## Staff Report to the Zoning Administrator

Application Number: **08-0373**

**Project Description:** Proposal to demolish an existing 3,656 square foot 4 bedroom, 3 ½ bath single-family residence and to construct a new approximately 6,995 square foot, two-story, 4-bedroom, 4 bath and two half-bath residence, including an attached 611 square foot two-car garage, and a detached 634 square foot 3-car garage with a 609 square foot second floor accessory dwelling unit above. Requires a Coastal Development Permit, a Residential Development Permit, a Level 5 approval for a second dwelling unit over 17 feet in height and a Preliminary Grading Approval.

Date: September 9, 2008  
To: Alice Daly, Project Planner  
From: Larry Kasparowitz, Urban Designer  
Re: New residence at 313 Kingsbury Drive, Santa Cruz

SITE PLAN / PRELIMINARY LANDSCAPE PLAN NORTH  
SCALE: 1/8" = 1'-0"

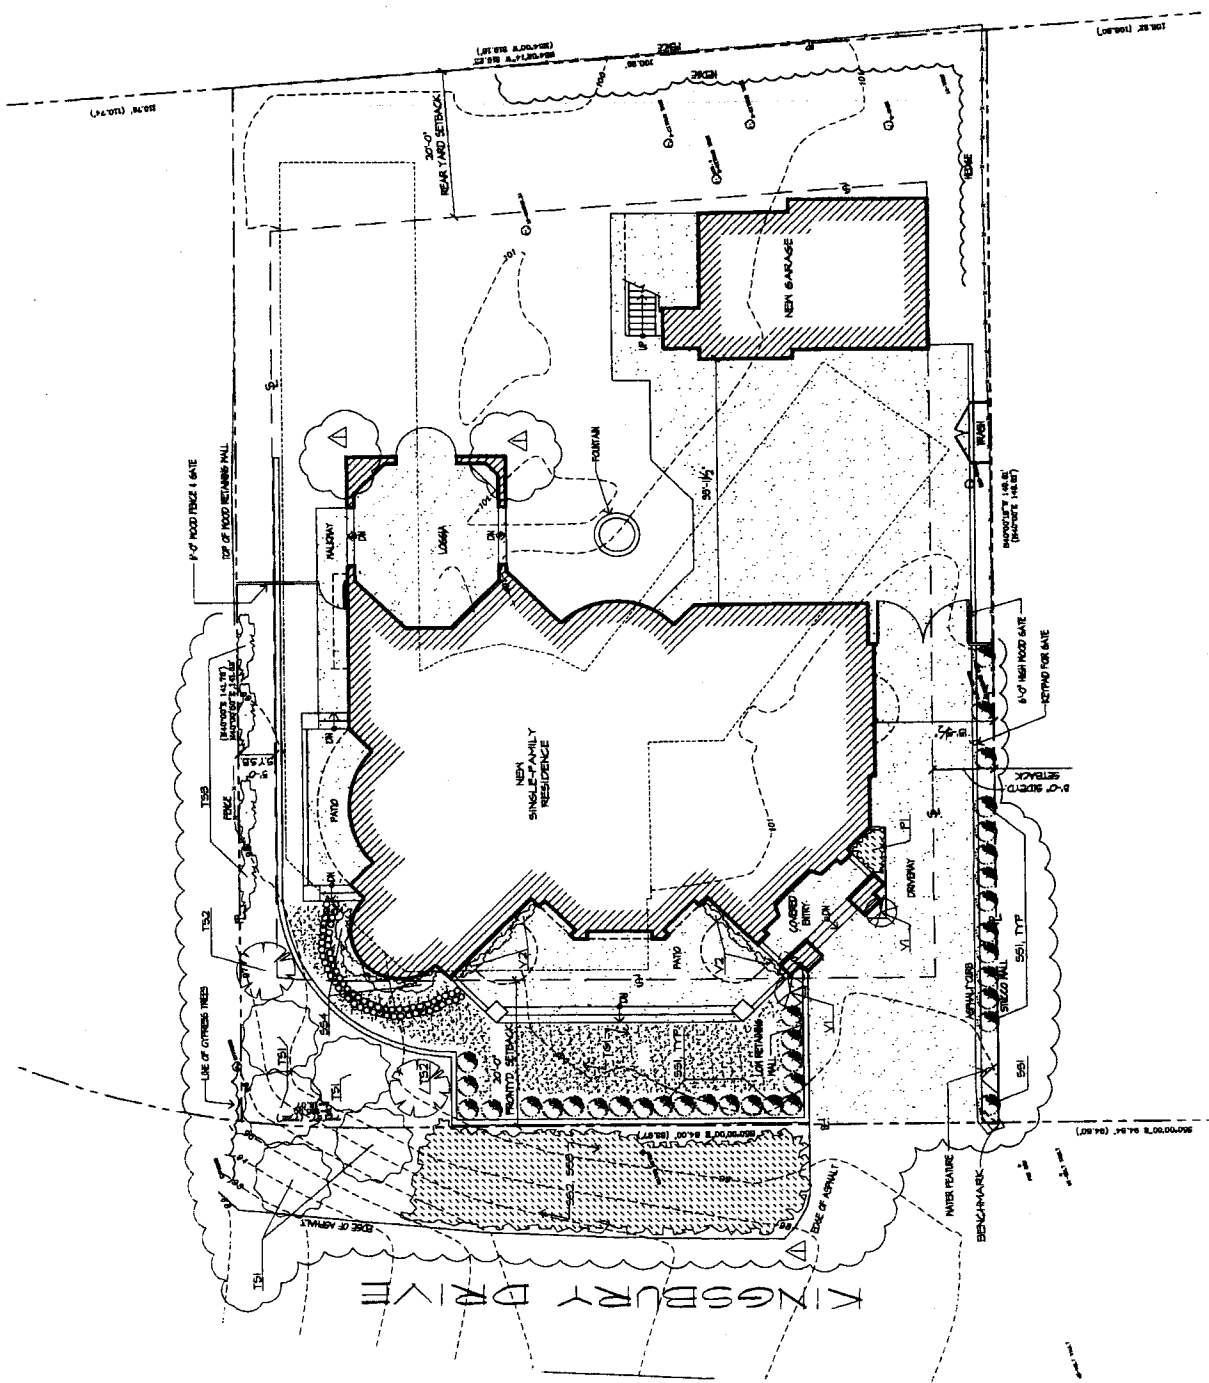
The re-submittal was again given a full review by staff. As discussed in the Urban Designer memo dated February 17, 2009, the project as proposed is still determined to not be in scale with neighboring structures and the overall character of the neighborhood. The street-facing elevation still gives an impression of overwhelming bulk and massing, and all four elevations have high horizontal cornices and other elements that contribute to the overall sense of a box-like form and formality. The revised project still appears out of context with its immediate setting, particularly given its size and siting on the parcel. The proposed landscaping does not sufficiently soften the massing.

- The building is pushed to the front setback and the rear half of the lot only contains the loggia and garage. This increases the impact of the bulk to the street
- All faces of the building contain two story walls. This gives a large "box-like" appearance – uniformly two stories.
- The cornice line of the building is almost continuous. This emphasizes the 21 ft. high plate lines.
- Cement plaster is the primary material for the walls. This limits the contrast of materials that would reduce the visual impact.
- A landscape plan was not submitted. It is unclear if the existing shrubs in the front are being kept which would decrease the visual impact from the street – new planting could assist in softening the massing and adding interest.

- The building is pushed to the front setback and the rear half of the lot only contains the loggia and garage. This increases the impact of the bulk as seen from the street.
- All faces of the building contain two story walls. This gives a large "box-like" appearance that is uniformly two stories.
- The cornice line of the building is almost continuous. This emphasizes the 21 ft. high plate lines.
- The new planting shown does not assist in softening the impact of the massing from the street.
- The building elements are not in scale (one meaning of that term is that in relationship to a person, they are out of proportion).
- The entire building is also not in scale with the neighboring structures, and will seem overwhelming at the street.

SOUTH AND WEST  
EXTERIOR ELEVATIONS

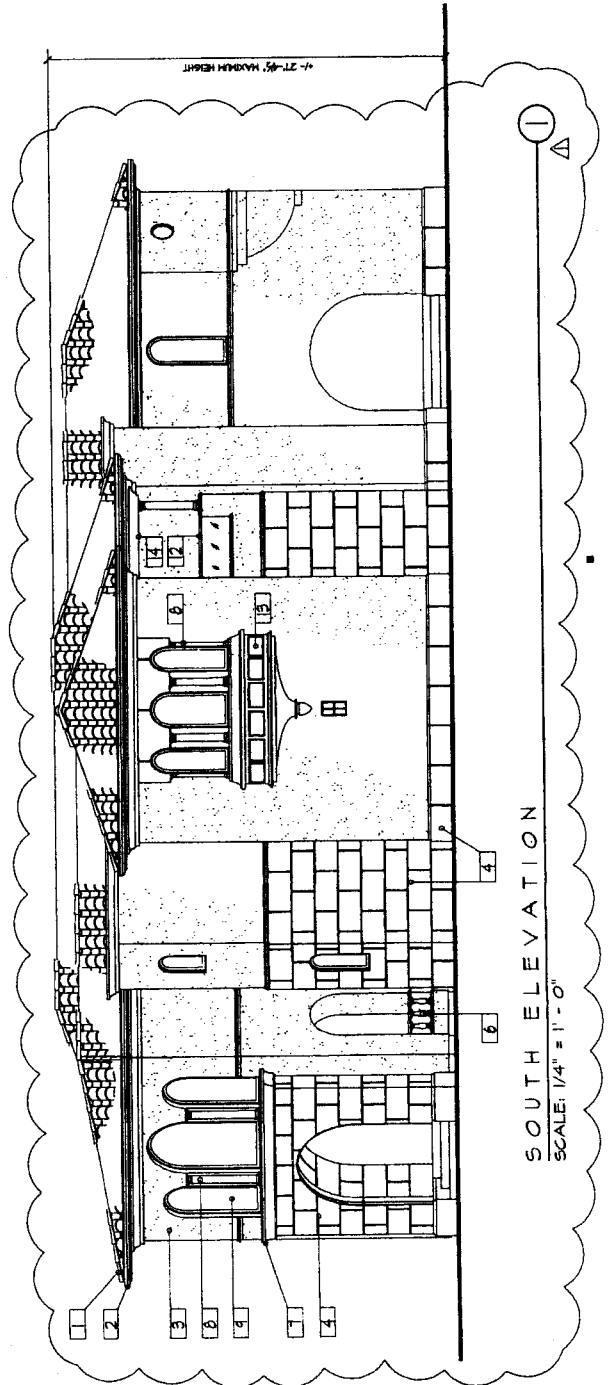
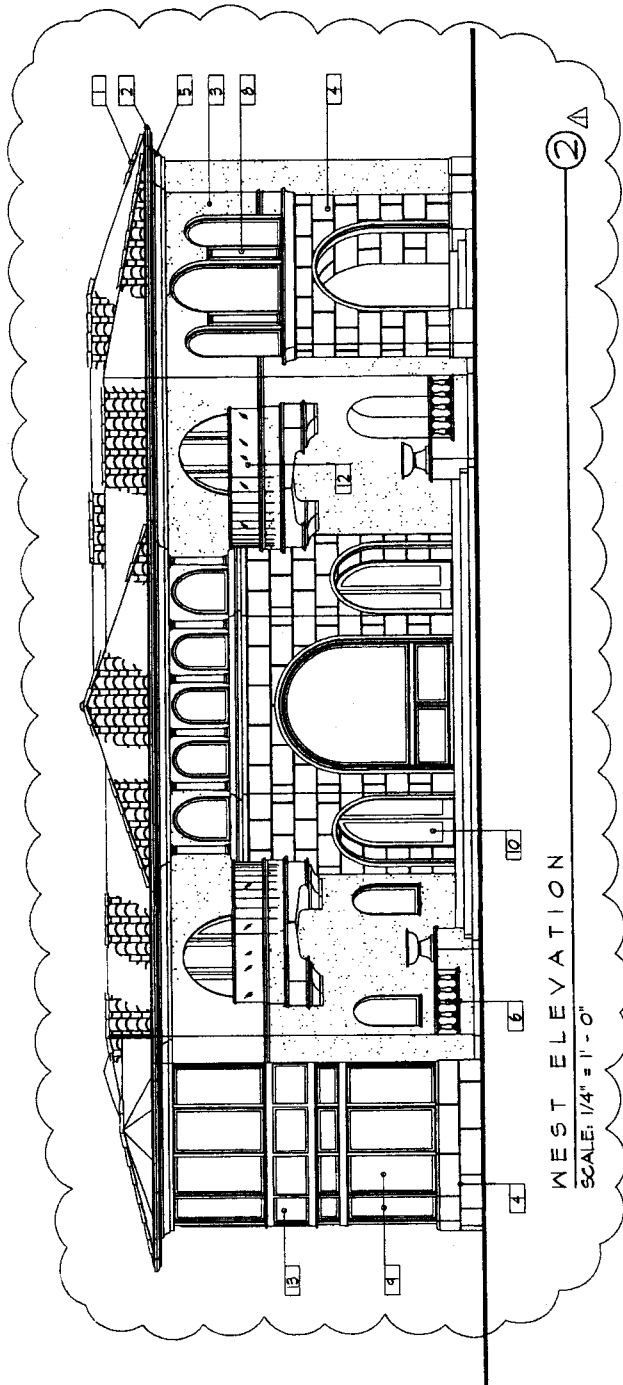
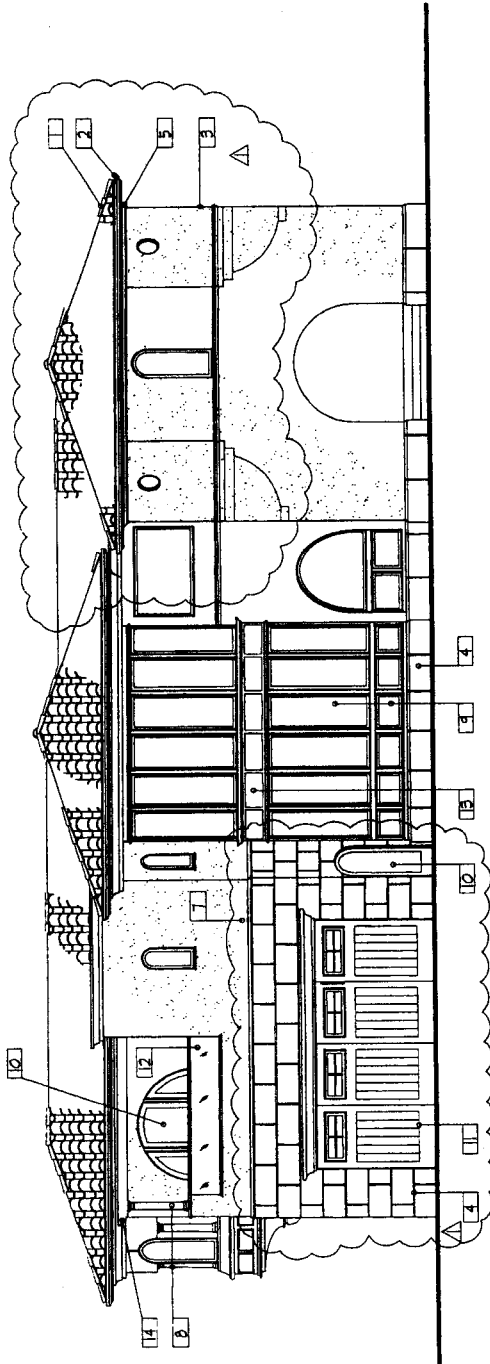
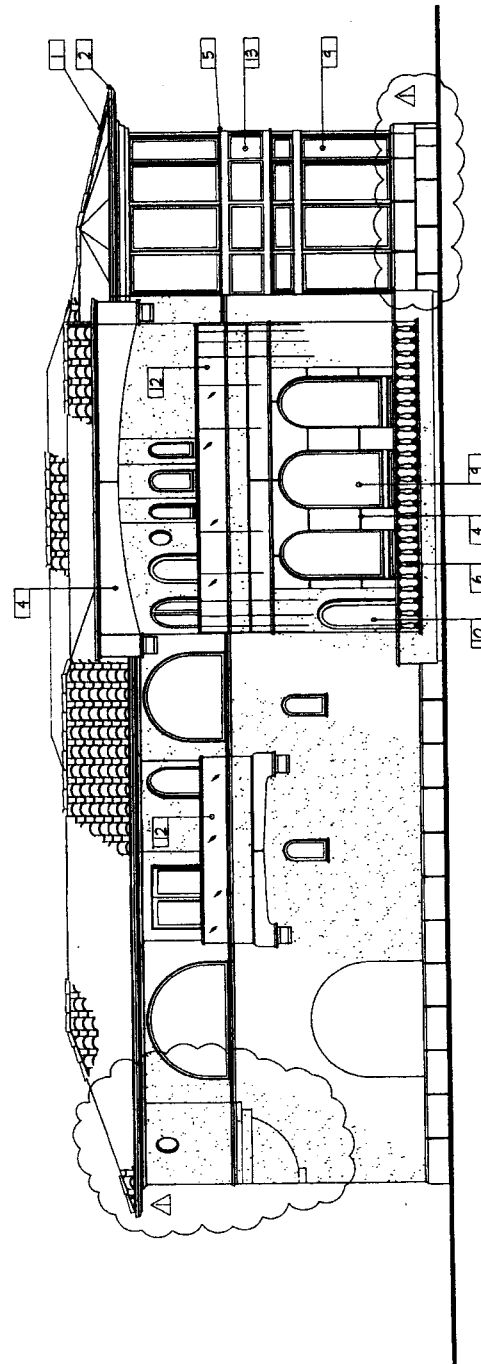
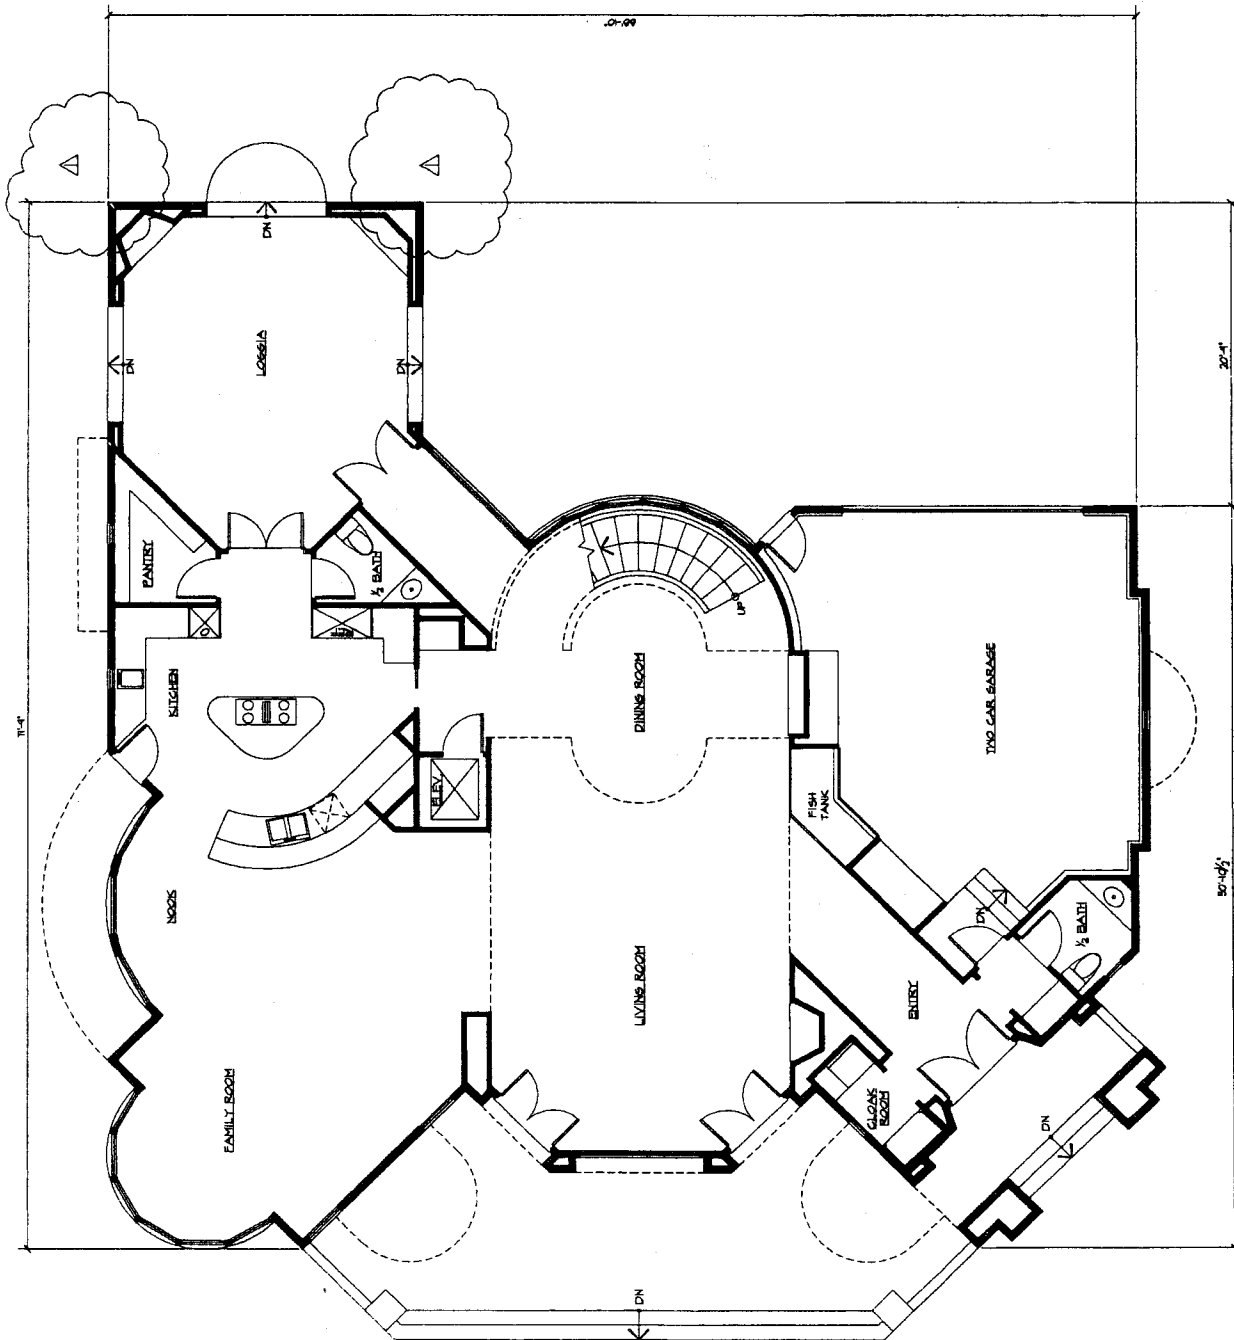
This finding cannot be made, in that the proposed residence and detached two-story accessory structure are not compatible with the surrounding neighborhood, largely due to their unrelieved two-story massing and bulk. While surrounding lots are developed with single-family residences in a variety of sizes and styles, the proposed new residence will appear more massive and formal than surrounding dwellings, and thus out of character and not visually compatible with the existing surrounding neighborhood. The siting of the dwelling on the parcel contributes to the lack of compatibility in that the two-story residence is proposed be placed right up to the Kingsbury Drive front setback line, thus exacerbating the sense of large massing from the street view that is out of scale with surrounding development.

This finding cannot be made, in that the proposed development is not compatible with the surrounding neighborhood because of its unrelieved 2-story massing and bulk. While surrounding lots are developed with single-family residences in a variety of sizes and styles, the proposed new residence will appear more massive and formal than surrounding dwellings, and thus out of character and not visually compatible with the surrounding neighborhood. The siting of the dwelling on the

parcel contributes to the incompatibility in that the 2-story residence is proposed be placed right up to the Kingsbury Drive front setback line, thus exacerbating the sense of large massing from the street that is out of scale with surrounding development. The landscaping proposed for the front of the parcel does not sufficiently soften the impact of the massing and bulk.
